DOC18/521407-1
SSD 7142

United Wambo Open Cut Coal Mine Project (SSD 7142) – Response to IPC Review

United Wambo Open Cut Coal Mine Project (SSD 7142) – Response to Independent Planning Commission Review

Figure 1. Screen shot of the Brosi offset with nine areas (red hatches outlined in red) where the boundary between Vegetation Zone 3 (pale brown) and Zone 4 (light chestnut brown) requires revision.

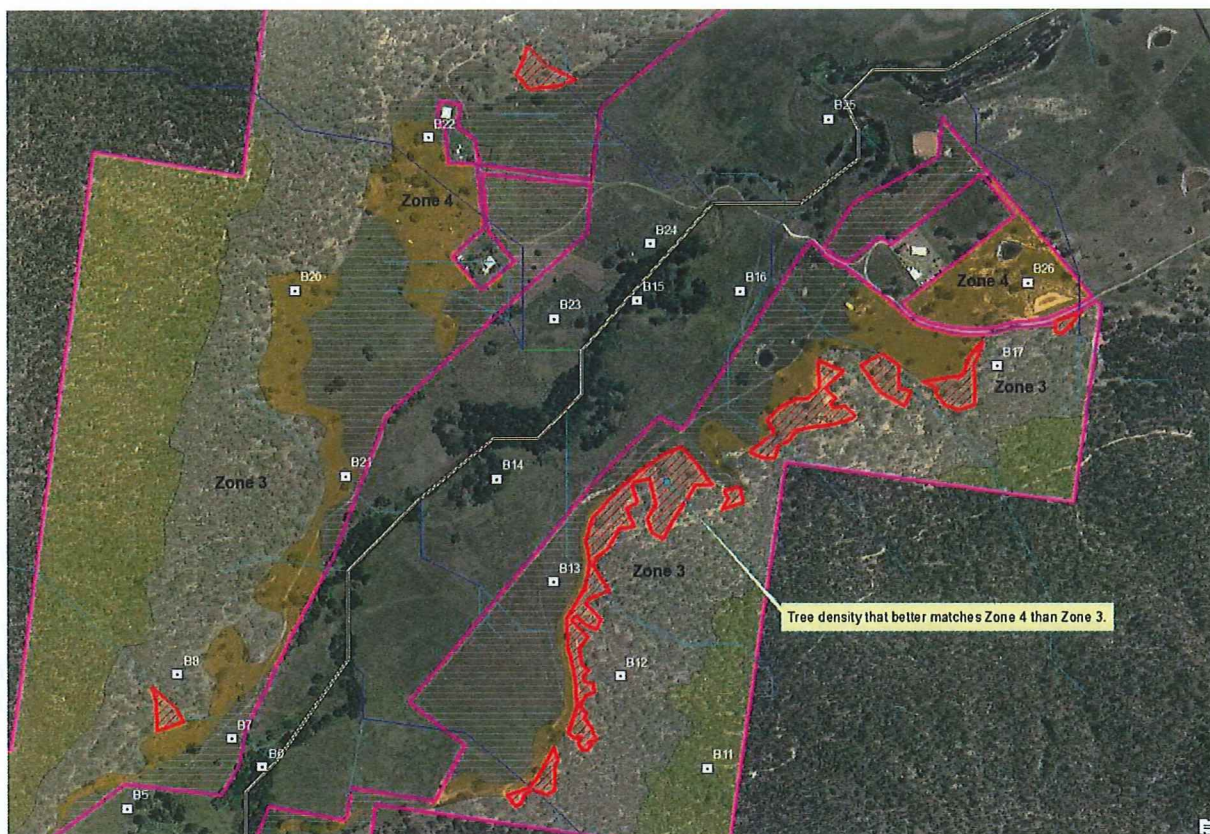
6. OEH recommends that the proponent reviews the mapping of vegetation zones 3 and 4 and considers mapping the areas shown in figure 1 as additional areas of zone 4. Any change to the area of vegetation zones will require the credit calculator to be re-run.

Vegetation Zones 3 (HU818 Moderate/Good condition) and 4 (HU818 Moderate/Good_other) on the Brosi offset have contrasting woody vegetation cover, with Vegetation Zone 3 covering relatively intact forest whereas Vegetation Zone 4 is a derived grassy woodland that has been heavily modified by human activity. OEH has identified about five hectares along the lower margin of vegetation Zone 3 that appear more appropriately mapped as Vegetation Zone 4 (See **Figure 1**, below).

OEH recommends that the proponent reviews the mapping of vegetation zones 3 and 4 and considers mapping the areas shown in figure 1 as additional areas of zone 4. Any change to the area of vegetation zones will require the credit calculator to be re-run.
